Determination 2009/50

The code compliance of a cement bonded particle board clad and steel framed house at 37/5 Driftwood Place, Mangawhai

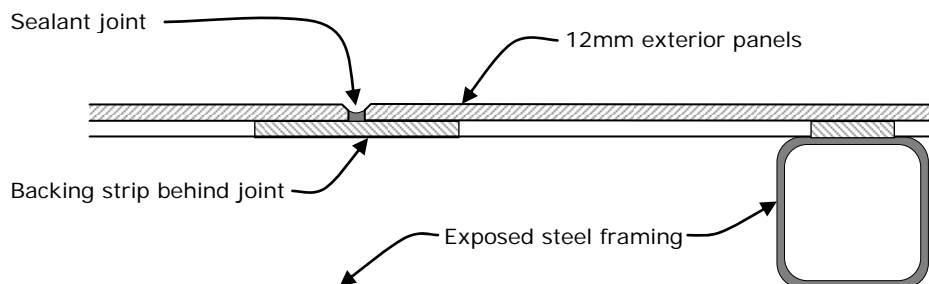
2.6.1 The expert reports that the exterior walls of the house part of this building are made up of exterior “sandwich” CBPB panels, infill CBPB “studs” of about 150mm x 50mm and interior CBPB linings as indicated in the following sketch:

2.6.2 The exterior CBPB panels are screw-fixed from the outside, with metal washers used at the screws. Metal angles are used as flashings at corners, with other joints sealant-filled. The expert noted that the house cladding is likely to have been supplied as prefabricated panels.
